SERVICE BULLETIN

SERVICE BULLETIN NO: 22-004

AUTOFLIGHT - AUTOPILOT PITCH ACTUATOR - REPLACEMENT

Wiring Diagram
Figure 1

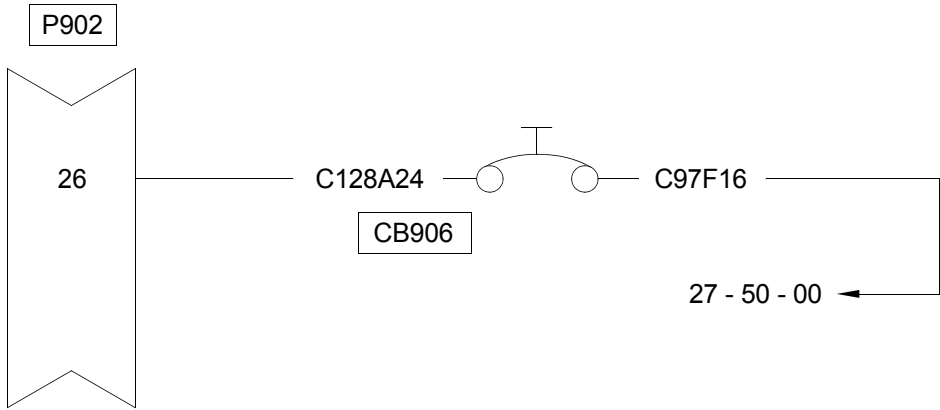
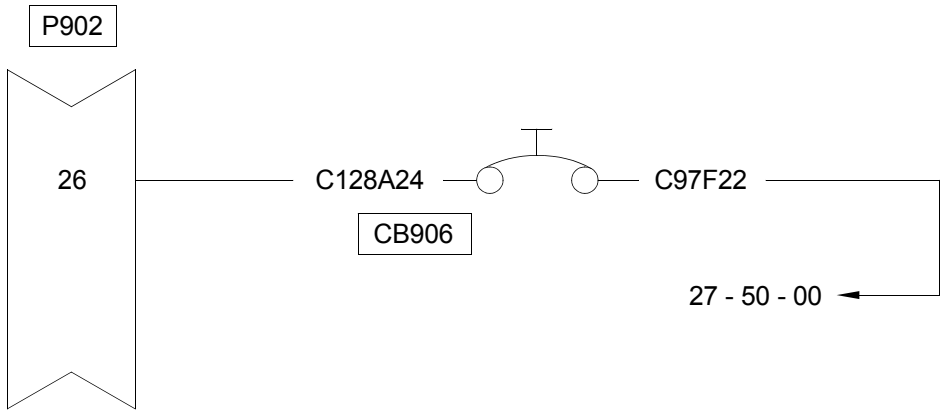
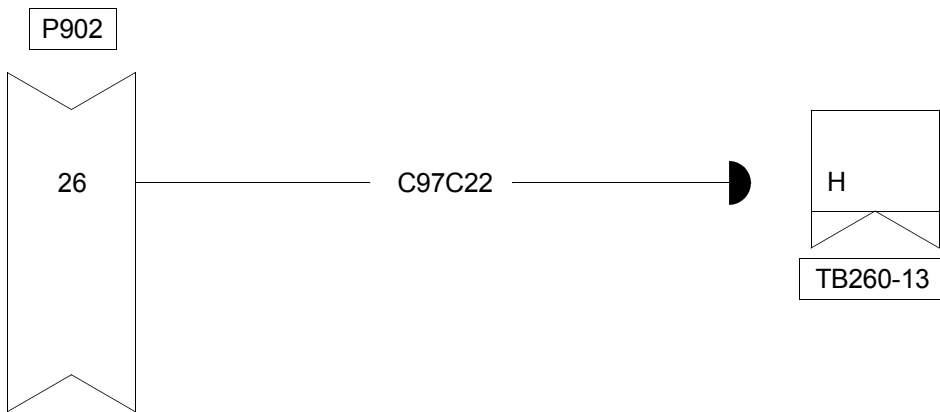
- (1) Disconnect and remove the pitch servo (Ref. AMM, 22-10-02, Page Block 401).
- (2) Make the wiring changes (Ref. Fig 1). This step is only applicable for aircraft MSN 321 and MSM 401 thru MSN 620.
 - (a) Disconnect the wire (C97C22) from terminal block (TB260-13/H).
 - (b) Remove the end connector from the wire (C97C22) then cap and stow.
- (3) Safety the circuit breaker (CB906) with the safety clip (110.88.07.065). This step is only applicable for aircraft MSN 101 thru MSN 320 and MSN 322 thru MSN 400.
- (4) Install the new pitch servo (Ref. AMM, 22-10-02, Page Block 401).
